Subject: R. E. Ginna Nuclear Power Plant
Docket No. 50-244
SEP Topics III-3.A, II-3.A, II-3.B, II-3.B.1
& II-3.C

Response to NRC Correspondence on SEP Topics
III-3.A (3/24/81) and II-3.A, II-3.B, II-3.B.1 & II-3.C (4/10/81)

SUBJECT: Trip Report Concerning Stone Revetment at R.E. GINNA Nuclear Generating Plant

CHECK OF CONTAINMENT CAPABILITY
TO RESIST EXTERNAL WATER PRESSURE

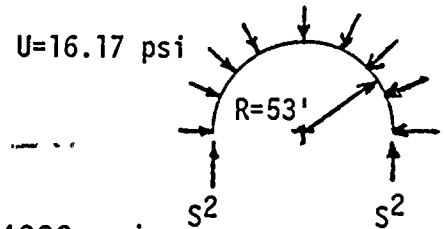
METHOD 1 - ASSUME CONTAINMENT IS A CYLINDRICAL SHELL UNDER UNIFORM RADIAL WATER PRESSURE

h = Water level = 22' high
 t = Thickness of containment = 36"
 R = Radius of containment = 53'
 f_c = Compression strenght of concrete = 4000 psi
 p = Max. water pressure
 = 62.4 X 22 = 1370/144 = 9.51 psi
 U = Design water pressure = 1.7 X 9.51 = 16.17 psi

$$S_1 = \text{Meridional Stress} = \frac{PR}{2t} = \frac{16.17 \times 53 \times 12}{2 \times 36} = 143 \text{ psi} < 4000 \text{ psi}$$

$$S_2 = \text{Hoop stress (comp.)} = \frac{PR}{t} = \frac{16.17 \times 53 \times 12}{36} = 286 \text{ psi} < 4000 \text{ psi}$$

$$P' = \frac{36}{53 \times 12} \frac{4000}{1 + 4 \times \frac{4000}{3.6 \times 10^6} \left(\frac{53 \times 12}{36} \right)^2}$$
$$= 94.8 \text{ psi}$$

$$\text{Safety Factor} = \frac{94.8}{16.17} = 5.86$$

EAST REVETMENT APPROX. 100 L.F. EAST OF WEST END. NOTE LARGE VOID UNDER CAP STONE (THIS VOID EXTENDS A TOTAL LENGTH OF ABOUT 25 L.F. TO RIGHT & LEFT OF PHOTO).

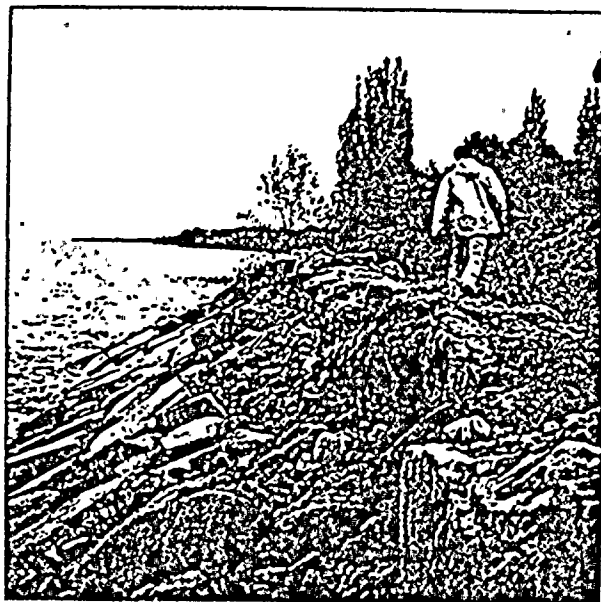
10. The area in the vicinity of the large void in the east revetment reach will be reexamined during the 13 November 1981 inspection. Our assessment of structural adequacy and any recommendations will be presented in the future letter report.

Photograph 9 - Test Pit in West Revetment revealing continuity of armor stone.

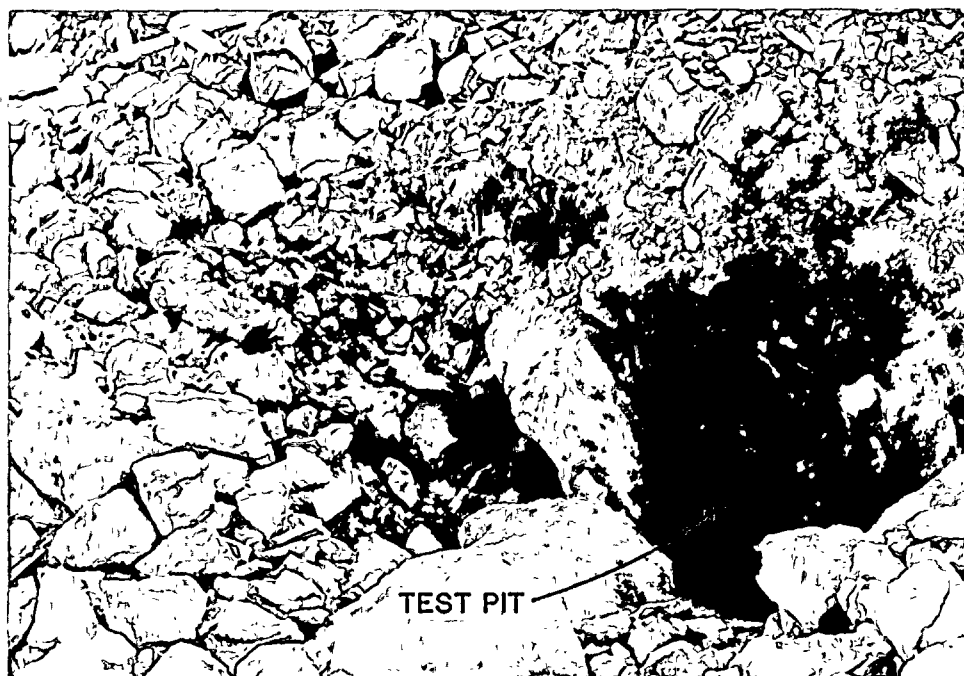
Three localized anomalous conditions were present in the armor layer. The first is a layer of fines (4 to 9-inch size) that veneer portions of the upper one-half of the revetments (Photographs 2 and 7). Test pits revealed the presence of a second layer of armor (Photographs 9 and 10). There was no evidence of removal of fines from the interior select fill of the revetment. The upper limit of coarse sand/gravel and drift deposition is below the lower limit of the 4 to 9-inch fines deposition which supports the lack of wave action/run-up that might cause removal of fines from the zone in question (Photograph 2, 3, and 10). Also, the lack of any distress in the cap stone layer tends to rule out removal of fines from wave action (Photographs 5 and 6).

Figure 11 - Localized slippage of armor stones in West Revetment.

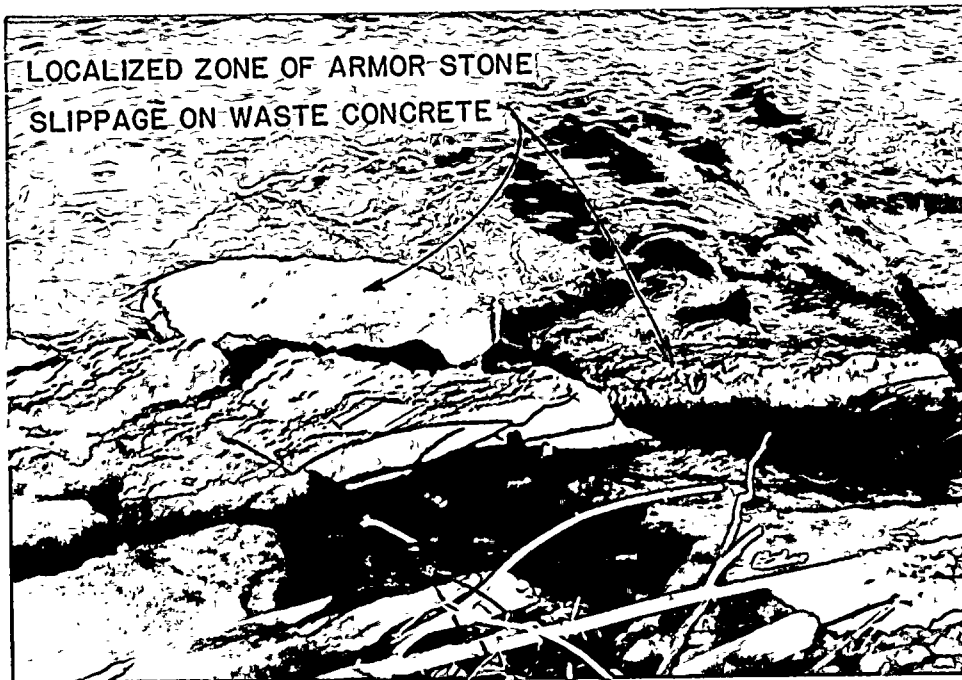
A second anomaly is a localized zone of slippage on the West Revetment. A few armor stones have migrated down the slope on waste concrete placed during construction (Photograph 11). The stones have displaced down the slope several feet in some cases resulting in a minor loss of rock to rock contact.

Photograph 12 - Large linear void in East Revetment beneath cap stones.

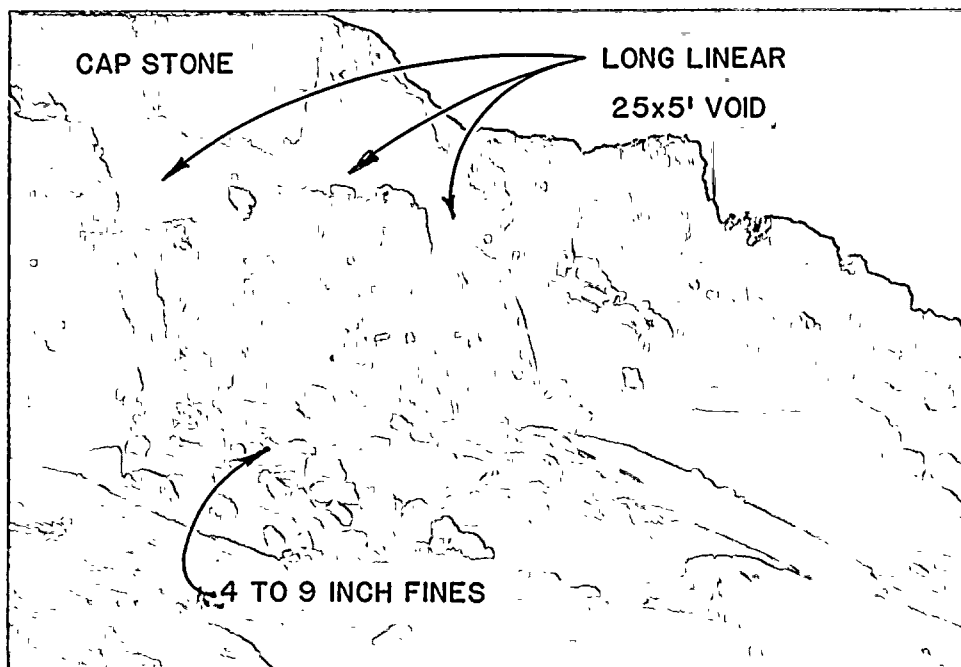
A third anomaly is located on the East Revetment. A rather long linear void (about 25 X 5 feet) is present directly under the cap stones (Photographs 12, 13, and 14). The void is located some 100 feet from the west end of the revetment. The utility stated that the void was a construction oversight; i.e., the void was present at end of construction. This appears to be the case; there was no evidence to indicate removal of fines from the interior of the revetment. Also, there was no distress in the overlying cap stone.
